**City of Bellevue
Development Services Department
Land Use Staff Report**

Proposal Name: Kepron Deck

Proposal Description: Critical Areas Land Use Permit to modify a steep slope buffer to construct a 492 square-foot deck. The proposal includes 492 square feet of steep slope and steep slope buffer mitigation with native steep slope buffer planting. The proposal is supported by a Critical Areas Report.

File Number: 21-108599-LO

Figure 1

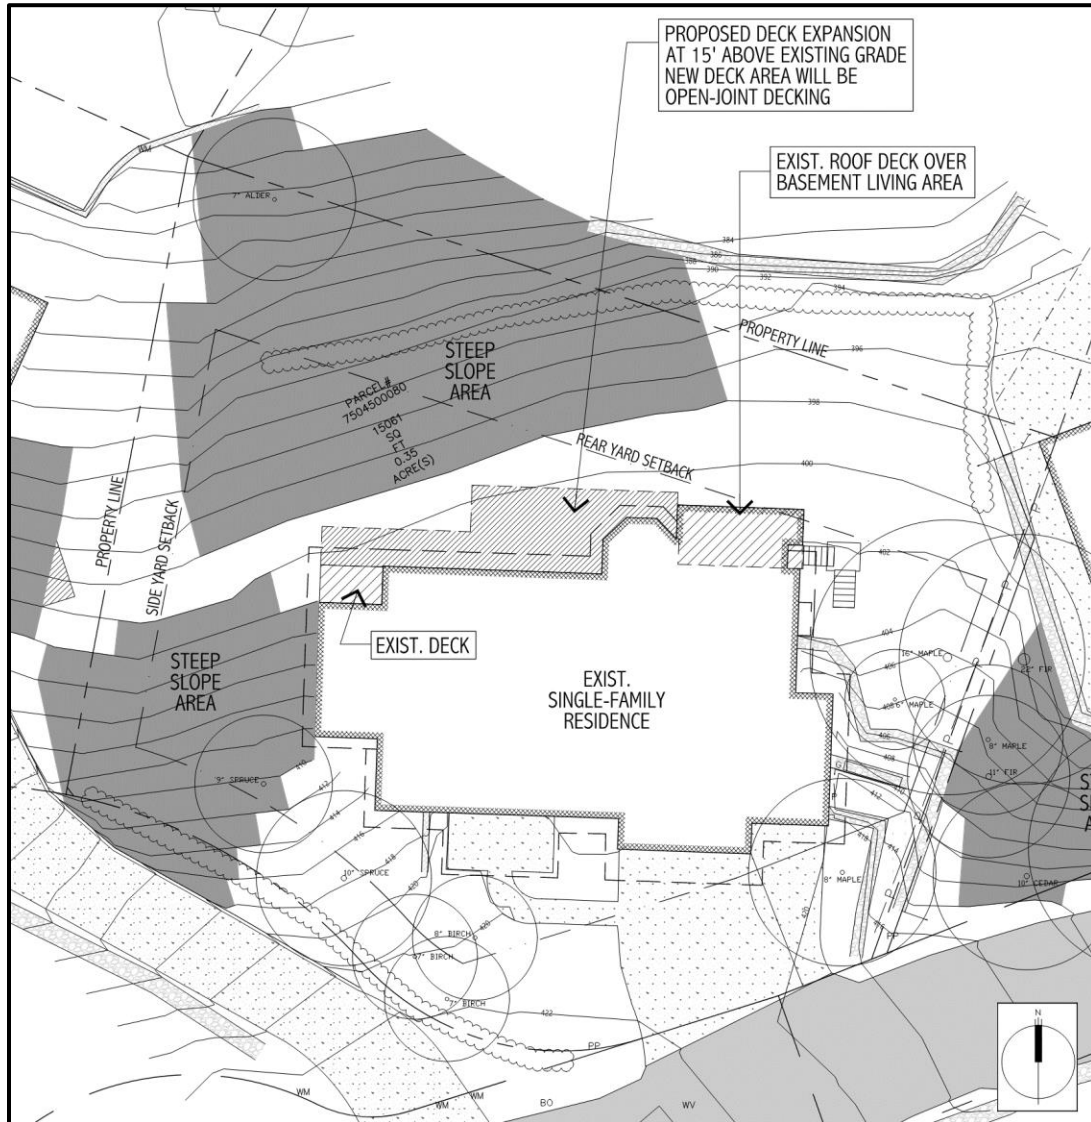
The applicant has requested a Critical Areas Land Use Permit approval to construct a 492 square-foot deck on the north side of the existing single-family residence. The proposed deck would be located within a disturbed portion of the code required 50-foot steep slope critical area buffer. The proposal includes approximately 492 square feet of buffer mitigation planting and removal of impervious surface within the buffer to improve degraded buffer conditions. See Figure 1 for proposed site conditions.
